AR46.40-P-0200-02C	Pressing out and attaching track rod joint at steering knuckle	
k	Surface protection on track rod screw connection to steering knuckle modified	BT46.40-P-0001-01A

Modification notes

P46.40-0240-01

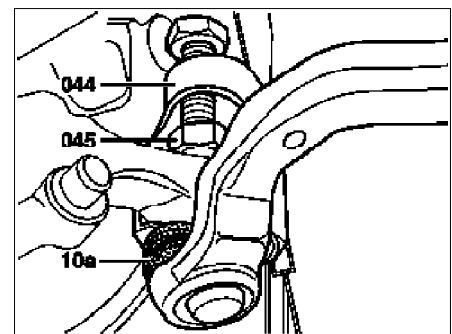
24.3.99	Surface protection on track rod screw connection to steering knuckle modified	Model 210	BT46.40-P-0001-01A
		New tightening torques incorporated	*BA46.40-P-1002-01A

Number	Designation	Model 210
BA46.40-P-1002-01A	Self-locking nut, track rod to steering knuckle	yellow Nm 60
		silver or blue Nm 70
